## COMMON COUNCIL MEETING AGENDA

JANUARY 17, 2023

**Item:** Traditional Neighborhood Development Planned Unit Development Amendment – Lakeshore Commons - 9116 S. 5<sup>th</sup> Ave., 9300 S. 5<sup>th</sup> Ave., and 4005 E. Lake Vista Parkway

**Lakeshore Commons**  
**Traditional Neighborhood Planned Unit Development (PUD)**  
**General Development Plan and Conditions and Restrictions**  
**AMENDED**

# EXHIBIT 6.2

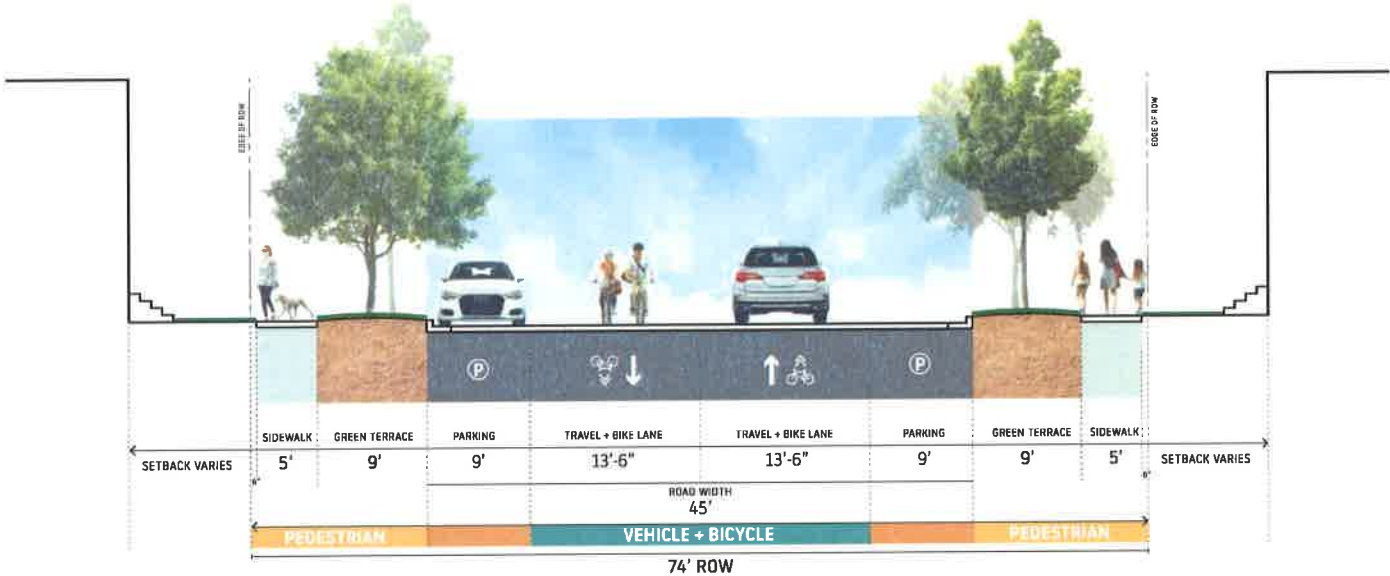
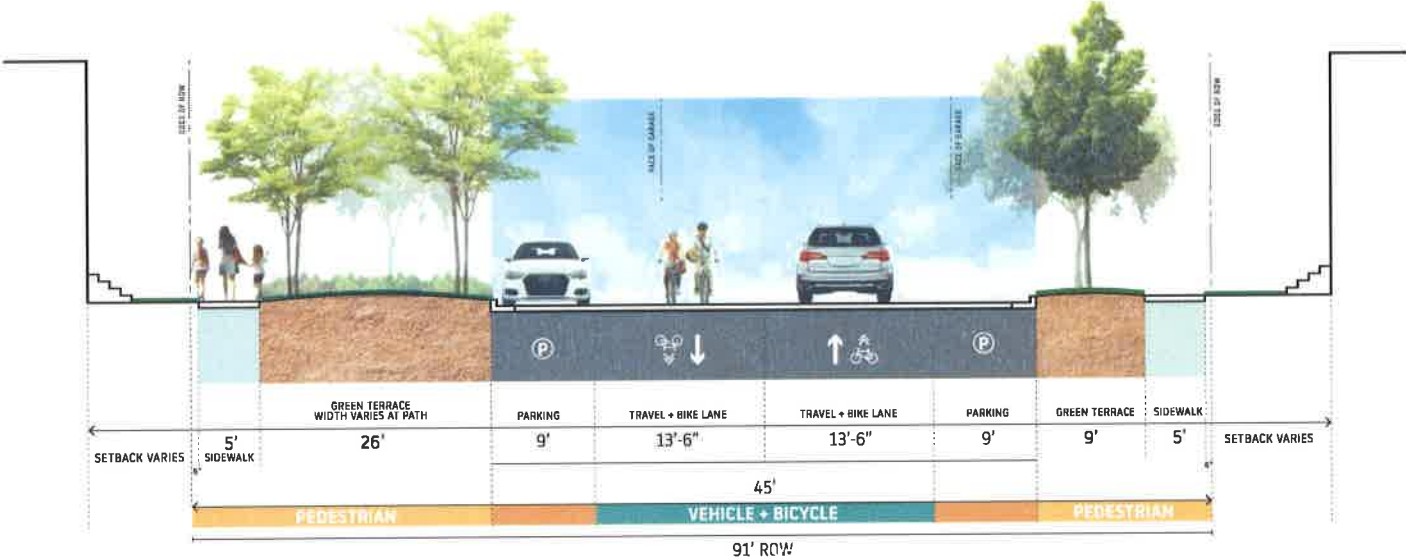
- e. Exhibits 6.1 – 6.4, Circulation and Cross Sections (Roads, Alleys) – updated per staff comments regarding legibility and requirements. Staff recommend that road names be included on the Exhibits as they have been finalized since the original Exhibit was created. Due to the change from the single-family attached villas to the 6-unit and 8-unit townhomes in the northwest corner along Lake Vista Parkway, the alley must maintain a full paved width per Fire Codes. Exhibit 6.4 should be updated to reflect this change, which will also require future Plan Commission Site and Building Plan reviews.

- o 6.2 - Circulation and Road Cross Sections
    - Roads 1, 3, and 5 sections changed to 13.5' Travel + Bike Lane and 9' Parking lane, to coordinate with approved engineering plans. No change to overall cross section width

## EXHIBIT 8 Development Signage

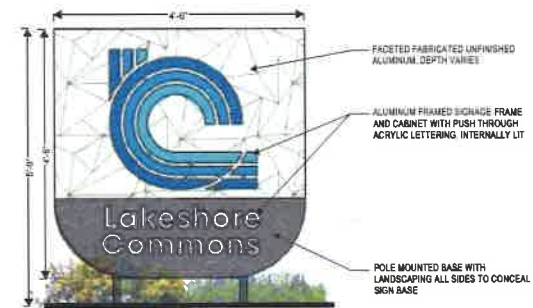
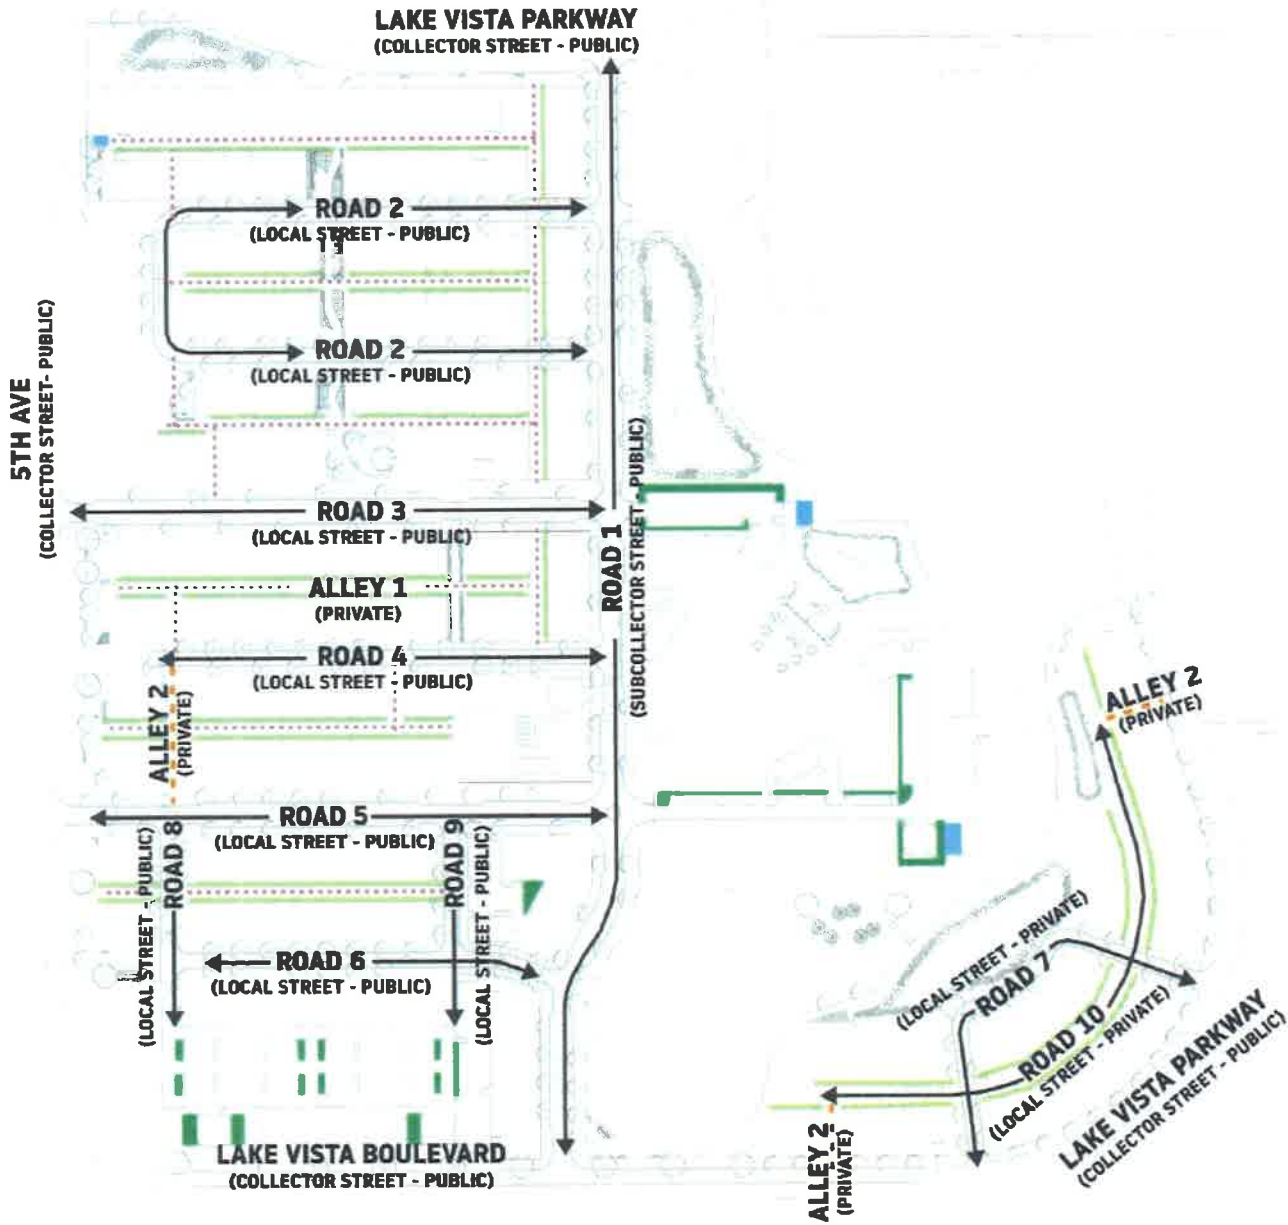
- 
- g. Exhibit 8, Development Signage – depicts the changes to the northwest, and shows updates to potential locations for development monument signs based on staff comments. However, staff have concerns for the number of signs proposed, some of the potential locations for secondary or building-specific signs, the notes, and the designs of the primary and secondary signs themselves. While the Conditions and Restrictions specify that a Master Sign Plan approved by the Plan Commission is required for the development, this Exhibit only refers to administrative approvals. Staff recommend that only the potential locations for the primary and secondary signage be shown, with notes updated to reflect that all signs require review and approval by the Plan Commission as part of a Master Sign Plan. Finally, the proposed design of the signs should be revised to incorporate a masonry base in conformance with Sign Code requirements.

# EXHIBIT 11.5 Setback Diagrams -Townhomes

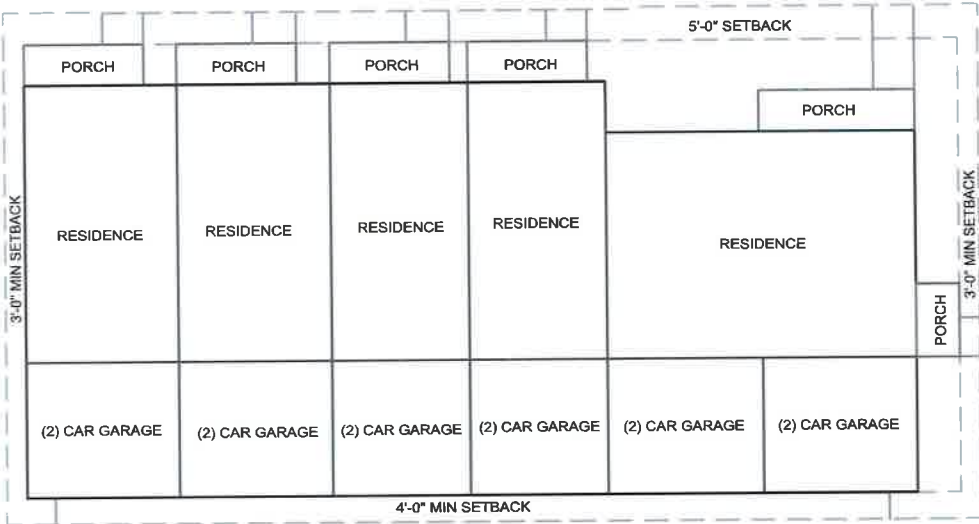
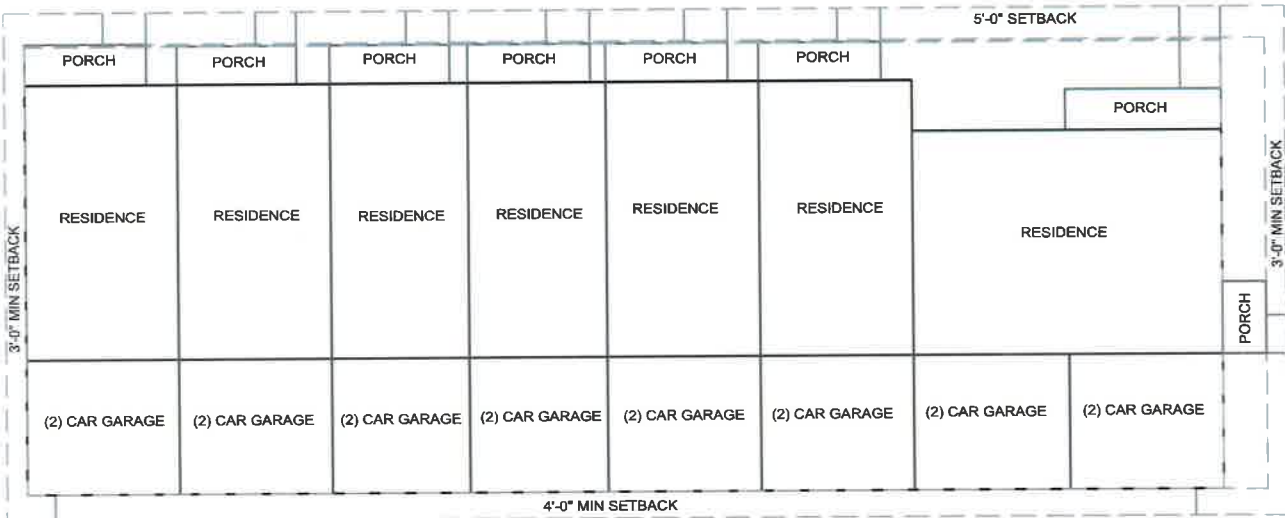
- j. Exhibits 11.1 – 11.10 – added to show setback diagrams for all areas and proposed buildings within the PUD. Staff note that these diagrams will need to be updated should the Council recommend approval of staff’s setback language.

2. City Question: Graphite III, 6, 8 & 9 unit townhomes – porch stairs may not encroach upon required front setback.

**RINKA response:** No change to design intent. The setbacks were intended to be to the primary front porch structure (not the stairs). With various grading conditions, it would be very difficult to confirm how many stairs are required to get up to the main floor elevation. Some houses have 1 step, some have 6+ at the front porches. ADK, Kapur, and RINKA are assessing stair quantity and location as each "lot" is purchased.
